Technical Service Information

VOLKSWAGEN/AUDI ZF5HP19FL/FLA NEUTRALS ON TAKEOFF

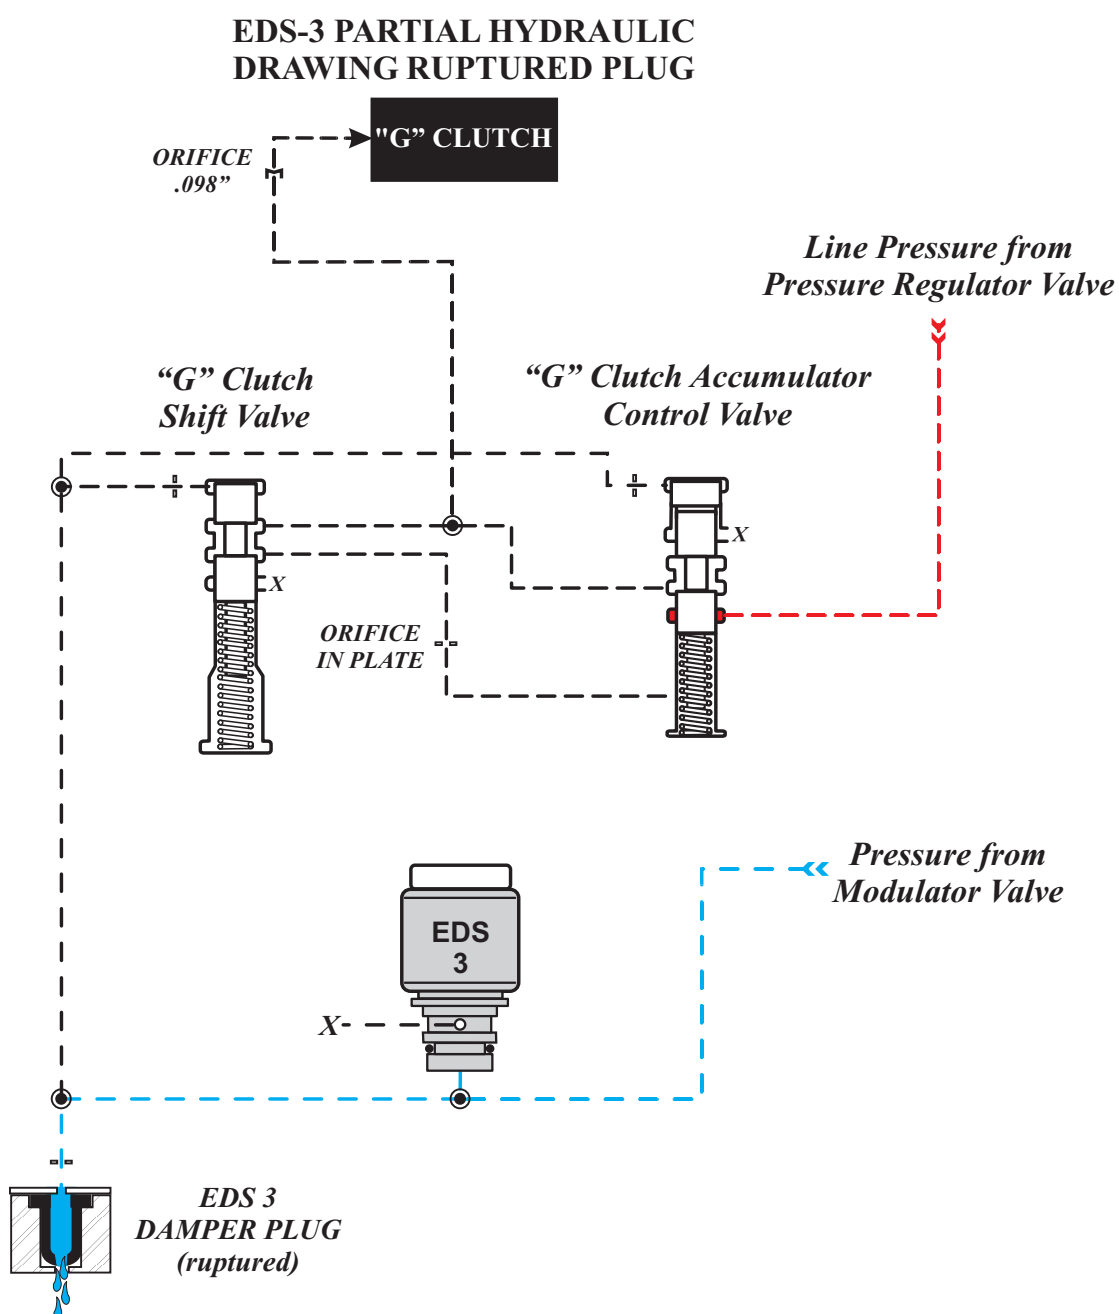
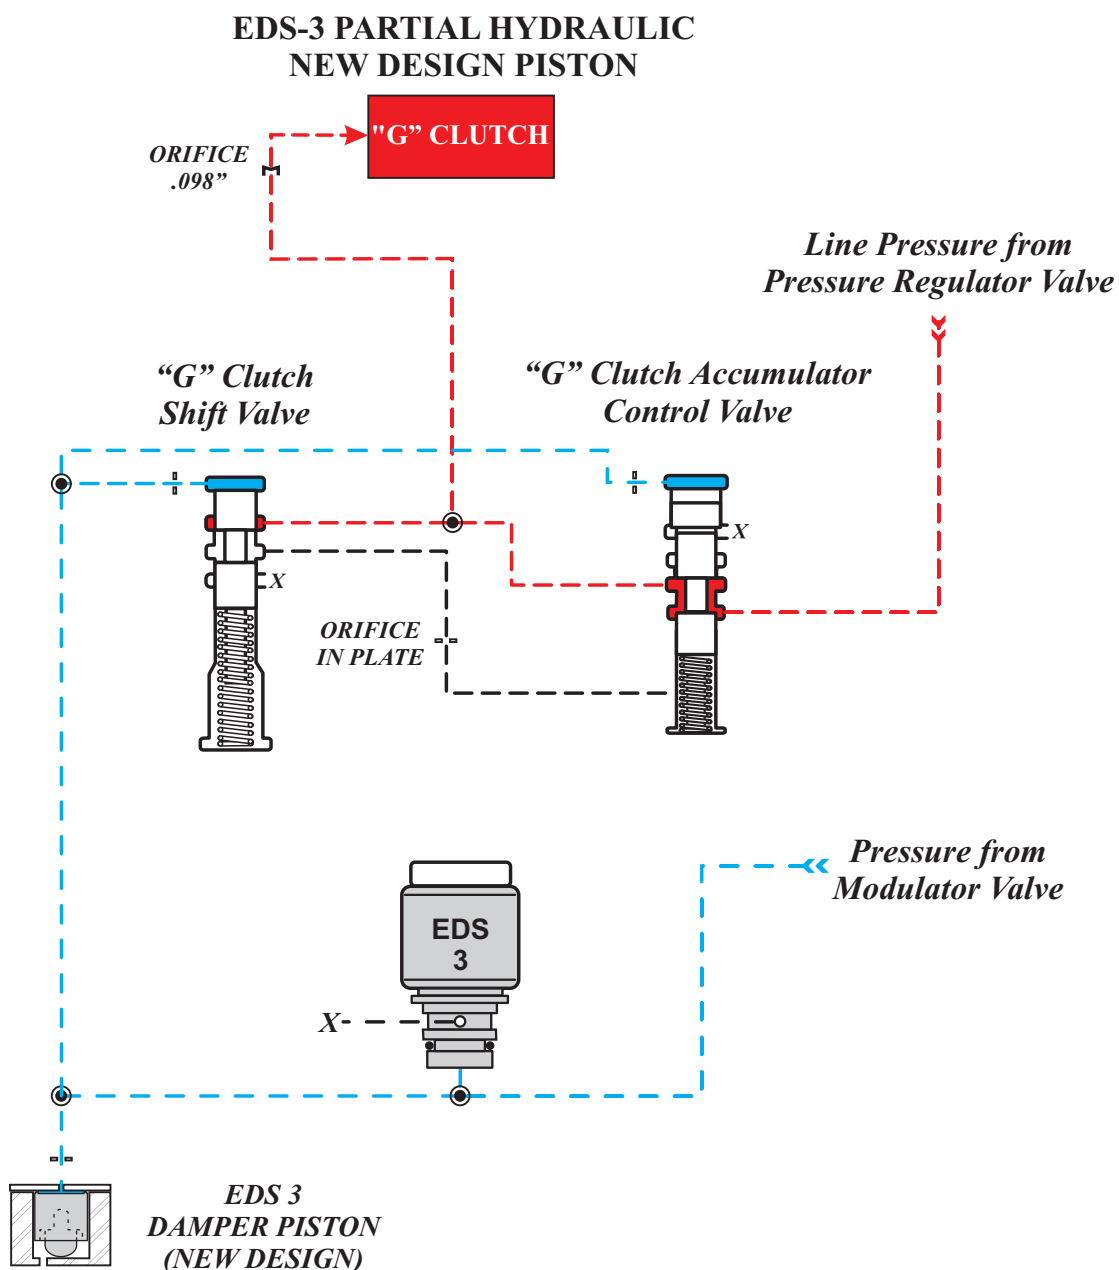
EDS 3 is used to control the engagement of the "G" clutch. This hydraulic circuit drawing shows oil flow with a ruptured EDS 3 Damper.

NOTE: *With a ruptured EDS 3 Damper Plug, EDS 3 oil pressure exhausts through the hole in the bottom of the damper plug thereby not accumulating and passing to both Shift Valve "G" and Accumulator Control Valve "G".*

This hydraulic circuit drawing shows oil flow with New Design EDS 3 Damper Piston.

NOTE: With a new design damper piston installed in the valve body, oil pressure only contacts the face of the plug. Since the hole is eliminated in the new plug, it reduces the possibility of the plug rupturing, and normal oil accumulation is achieved.

Figure 2
AUTOMATIC TRANSMISSION SERVICE GROUP

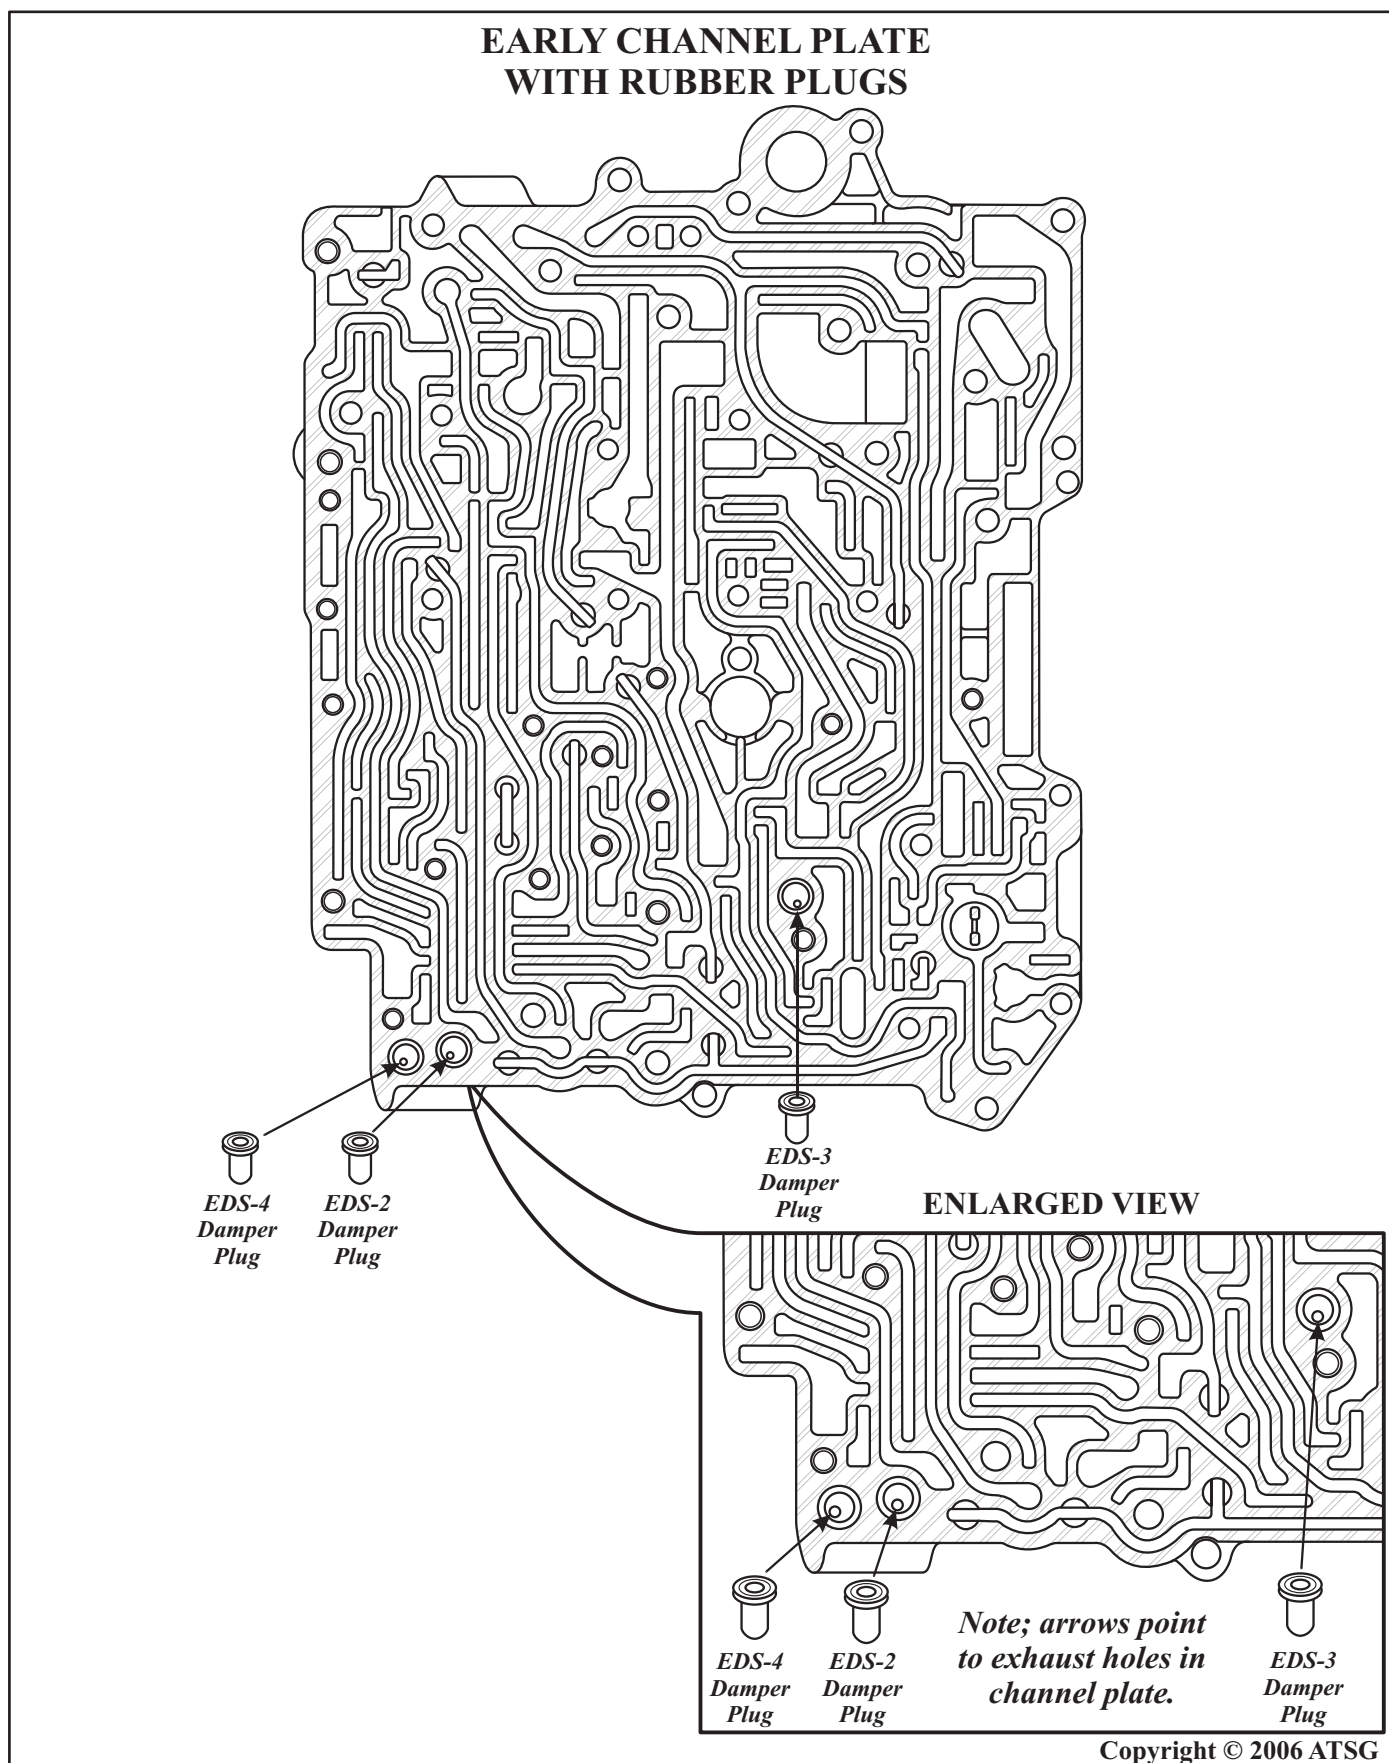
CORRECTION: Replace the rubber damper assembly, or use the updated aluminum plugs which requires the updated channel plate and spacer plate. Refer to Figure 2 this picture shows the channel plate with the EDS damper plug locations, and also an enlarged view which shows the early style rubber plugs and focuses on the exhaust holes in the channel plate. These rubber damper plugs were used in ZF5HP19 models through 1999. During model year 2000, ZF introduced an updated damper assembly. Figure 4 shows worm track differences in the later channel plate and also an enlarged view which depicts the later style damper pistons and illustrates the bore size difference in the channel plate for the later damper pistons. Refer to Figure 3. This drawing illustrates the same partial hydraulic circuit in Figure 1, *except*, it shows the new design EDS 3 accumulator piston. Notice the top of the accumulator piston, there is no orifice like in the previous plug, instead the surface is solid and in the bottom of the plug is a rubber insert that provides the cushion, or accumulation. The solid top obviously prevents rupturing and these new pistons eliminate the problem.

Figure 4

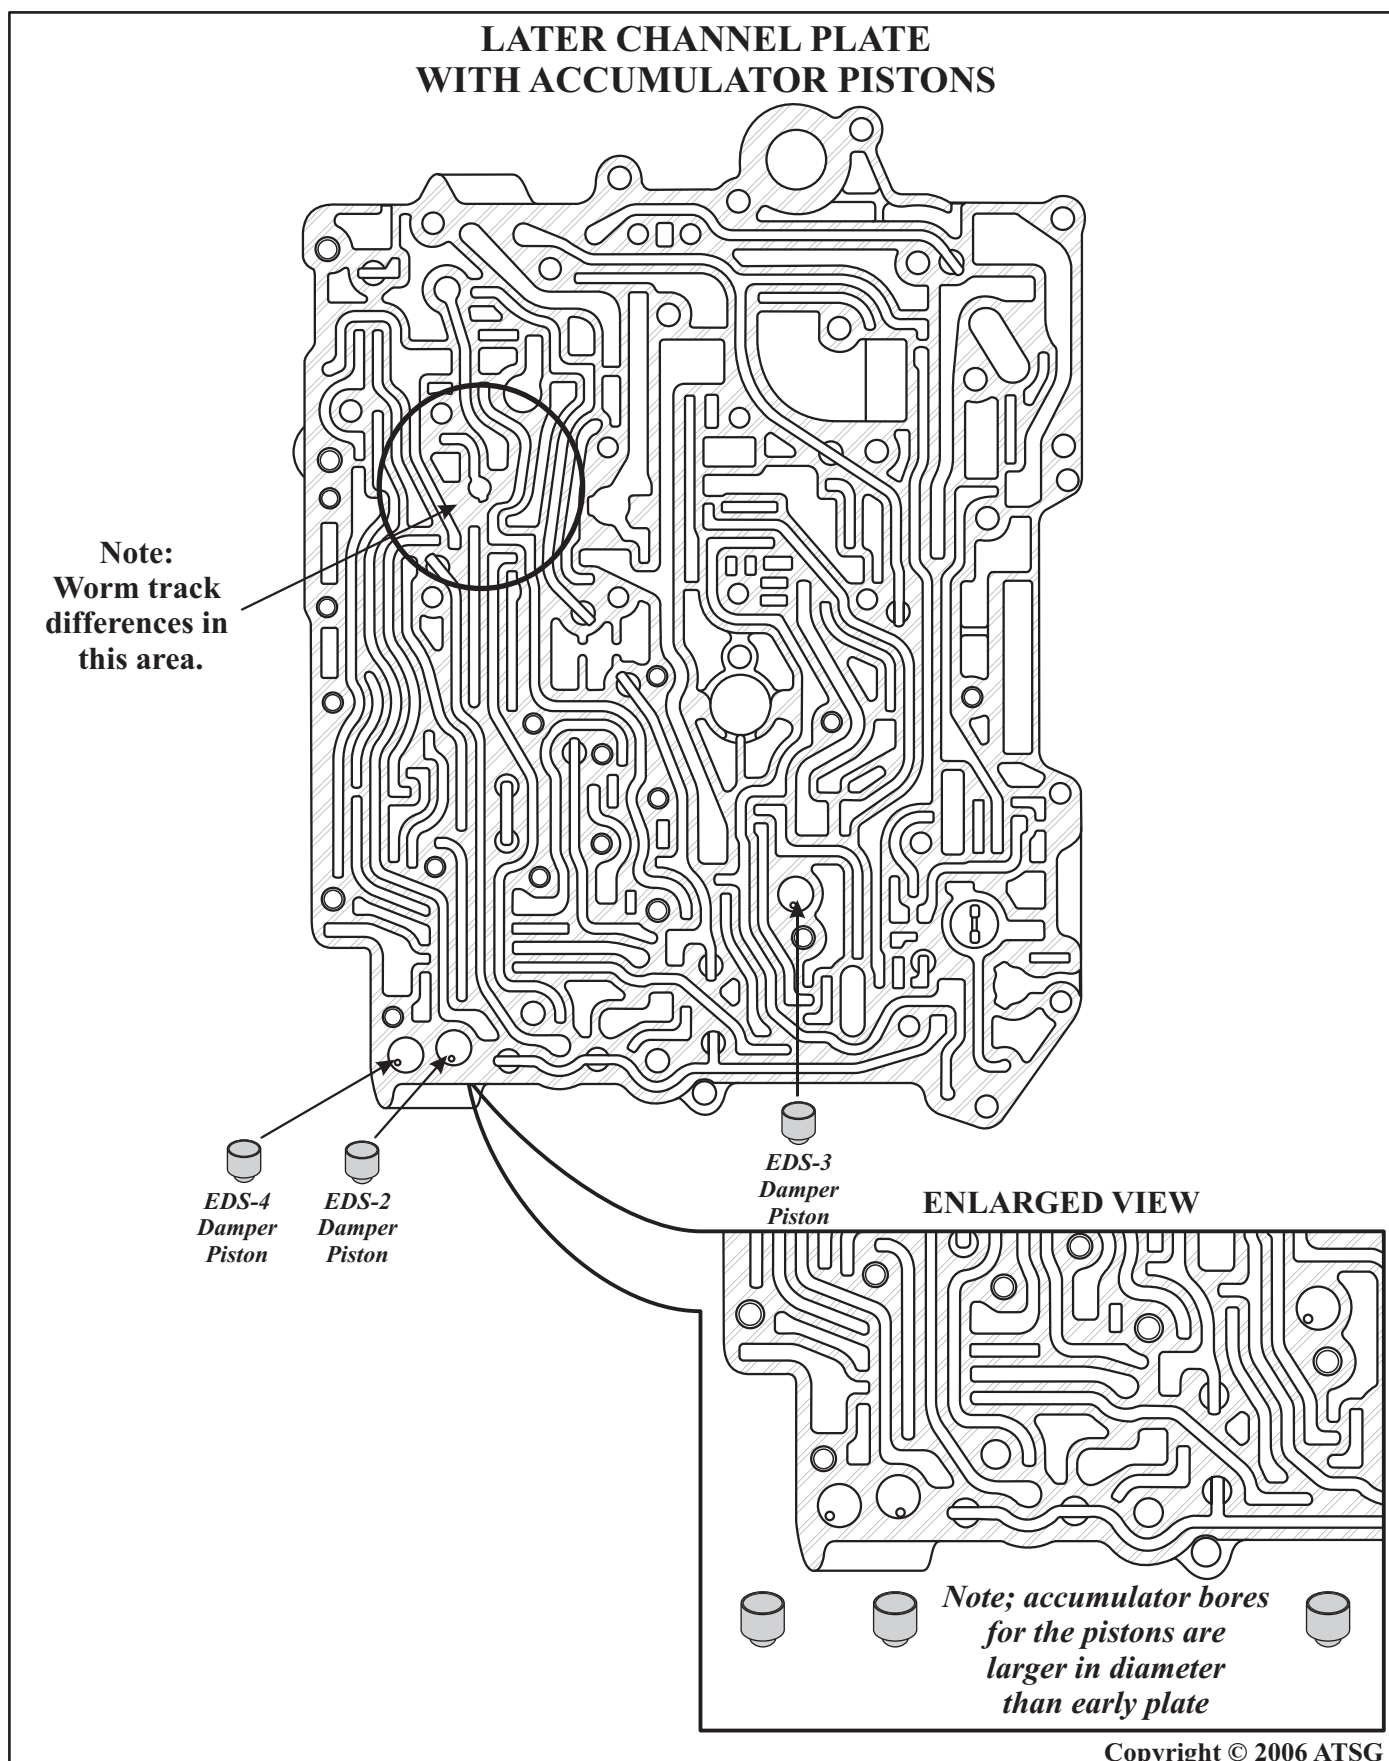
Refer to Figure 4. The text in the enlarged view states the accumulator bores in the channel plate are larger in diameter than the early plate. The bores are larger in diameter to accommodate the updated pistons. The diameter of the accumulator plug bore in the early channel plate is approximately .315 inches and houses the rubber damper plug. The outside diameter of the accumulator piston bore in the later channel plate is approximately .471 inches in diameter for the updated piston. Figure 5 shows the early valve body separator plate, and Figure 6 shows the later separator plate. Note the differences in hole size and configuration between the two plates. ***They are not interchangeable.*** Therefore, if you have a rubber damper that is ruptured, you will have to use a new rubber damper. If you want to use the later style piston to prevent a future incident, you will need to purchase a new channel plate, separator plate and pistons from a ***ZF-AUTHORIZED*** distributor. Most overhaul kits will come with both the rubber plugs and the newer pistons so if you have an overhaul kit you will only need to purchase the new style separator and channel plate. ***Note:*** There are two different versions of the separator plate and channel plate combinations, the first version is the type that has a Pulse Generator, which supplies Turbine shaft speed to the TCM, and is bolted to the middle of the channel plate. The second version is the type that uses a Hall effect turbine speed sensor, which is bolted the case. These 2 different channel plates are not interchangeable. Refer to the chart below for the correct part numbers for the version needed.

**NOTE:
SEPARATOR PLATE
DIFFERENCES**

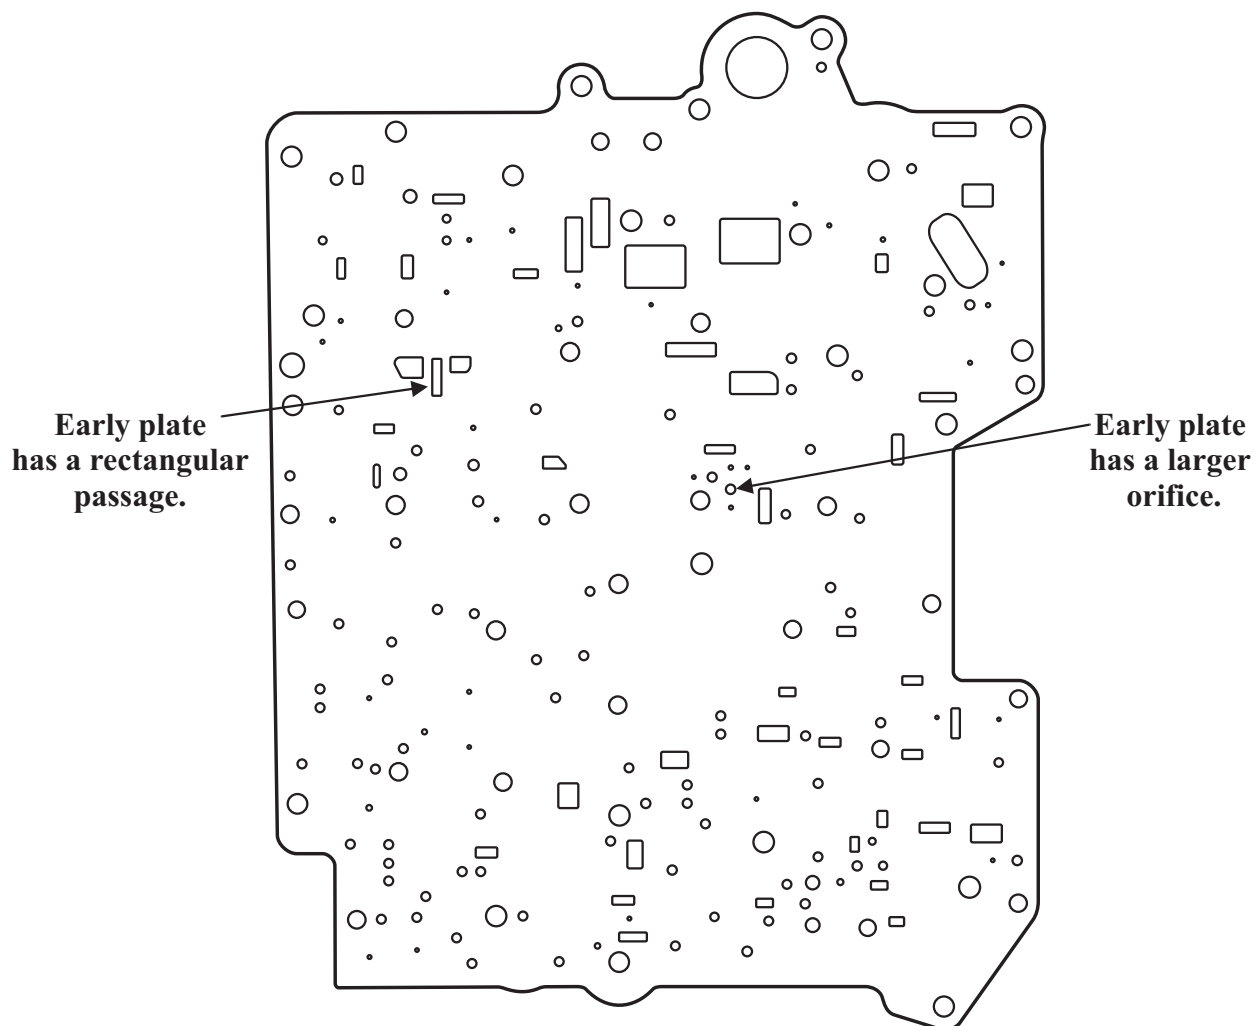
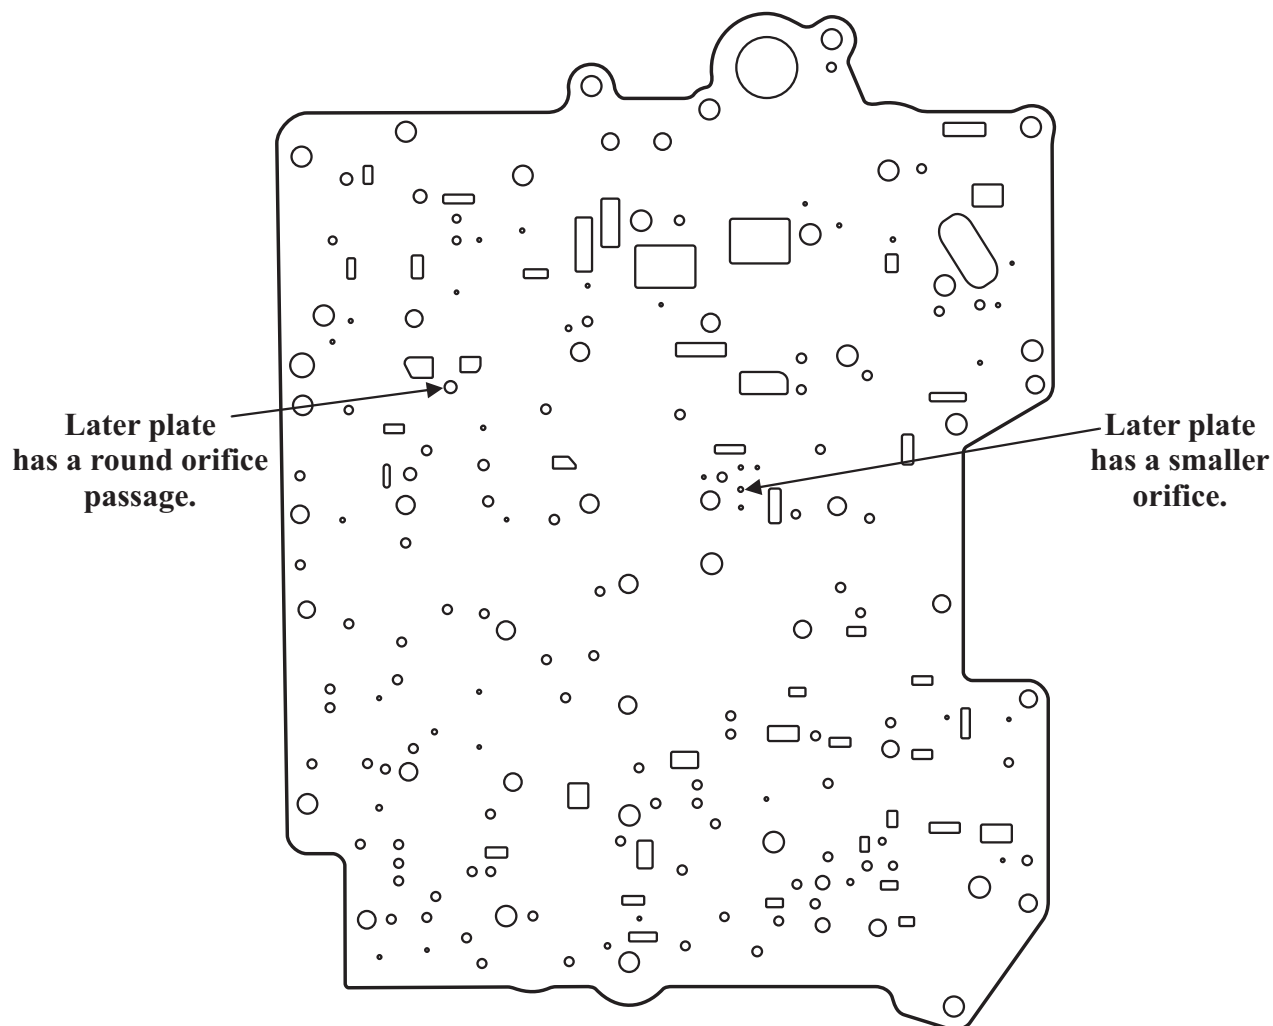
EARLY STYLE SEPARATOR PLATE

LATER STYLE SEPARATOR PLATE
